## **MAJOR PROJECT ASSESSMENT** ***Erskine Park Link Road Network*** ***Concept Plan***

**Director-General's Environmental  
Assessment Report**  
**Section 75I of the *Environmental Planning and  
Assessment Act 1979***

**August 2009**

**Figure 4 – Proposed Network, as originally proposed (Black) and as modified in the Preferred Project Report (Blue)**

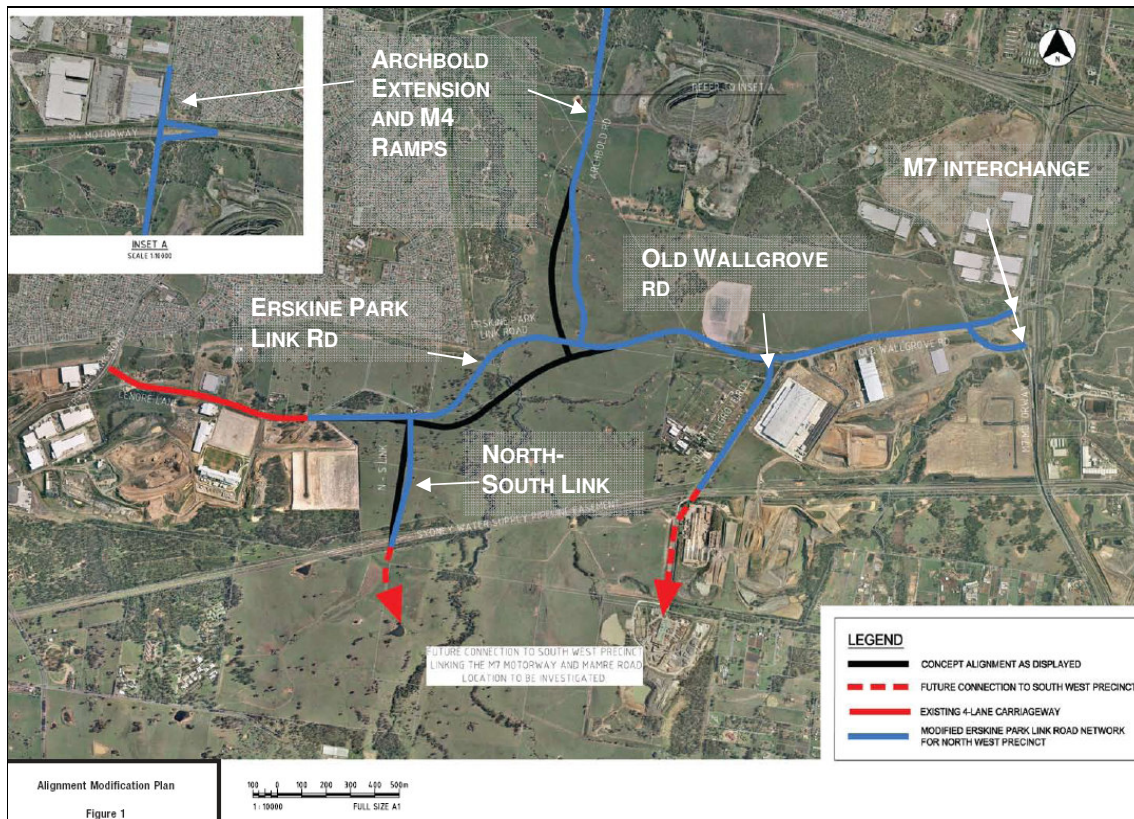
Key features of the road network (as modified by the Preferred Project Report in response to submissions) are detailed in Table 1 and illustrated in Figure 4 below. These changes are considered to not substantially deviate from the original proposal and were largely in response to submissions from landowners and Penrith City Council. Consequently, the PPR was not publicly exhibited for further comment. However, in accordance with the Act, the PPR was placed on the Department's online Major Project Register.

Figure 6 – Original (Black) and Revised Alignment (blue), as presented within the PPR

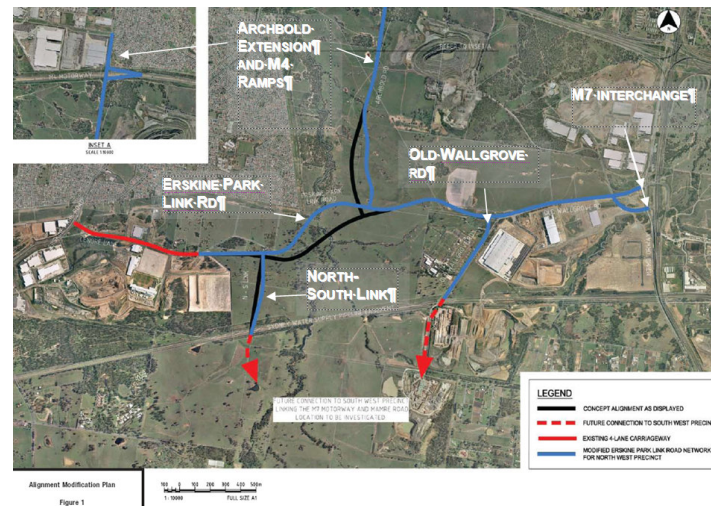
On 16 February 2009, the Proponent submitted its response to the above submissions and a Preferred Project Report. The key modifications to the project (as illustrated in Figure 6) are:

- **Realignment of the southern portion of Archbold Road** further to the east. This also results in the relocation of the Erskine Park Link Road/Archbold Road intersection 50m north;
- **Realignment of the Erskine Park Link Road** between the intersection of the N-S Link and 100m west of the Archbold Road intersection to the north to align closer with the Penrith City Council proposal. This also results in the relocation of the Ropes Creek crossing approximately 150m north of the original proposal; and
- **Realignment of the N-S Link** to 50 metres east of the original alignment.

Overall, the Department is satisfied with the proposed changes to the alignment, subject to the recommended modifications.

**Figure 8 – Population of Juniper Leaved Grevillea (SKM, Nov 2008)**

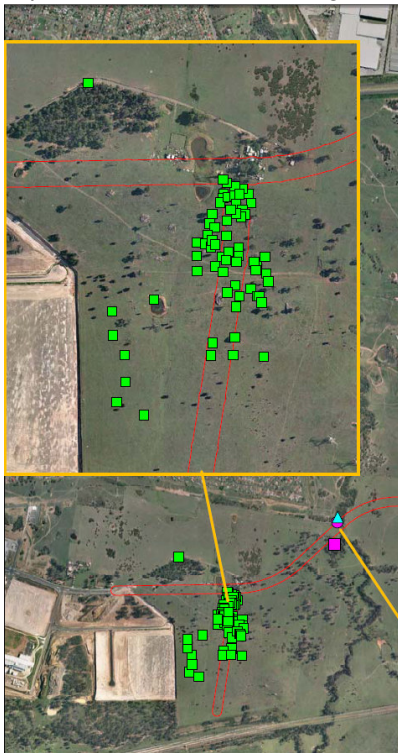
The DECC raised concerns regarding the adequacy of the flora and fauna assessment, and requested that surveys be undertaken to inform the location of the proposed road alignment. DECC was particularly concerned that there was potential for *Pimelea spicata* (a significantly threatened flora species) to be present within the site and that acquisition corridor identified within the draft SEPP would significantly reduce the opportunity for alignment changes to occur to protect this species.

This population of Grevillea, located within the road reserve for the Erskine Park Link Road (west of Ropes Creek) and the N-S Link, consists of 500 individuals (refer to Figure 8). 286 individuals (or 57%) will require the direct removal as a result of the proposed road. The remaining individuals will be subject to indirect impacts due to increased fragmentation.

The Department commissioned a survey of the proposed road network (as modified). This assessment (provided in Appendix G) concluded that the impacts on flora and fauna would not constitute a significant impact subject to the implementation of mitigation measures, with the exception of the proposed clearing of 1.7 ha of habitat for the Juniper Leaved Grevillea (a vulnerable species listed under the *Threatened Species Act 1994*). A number of mitigation and management measures have been recommended, which have been incorporated into the future assessment requirements for subsequent applications.
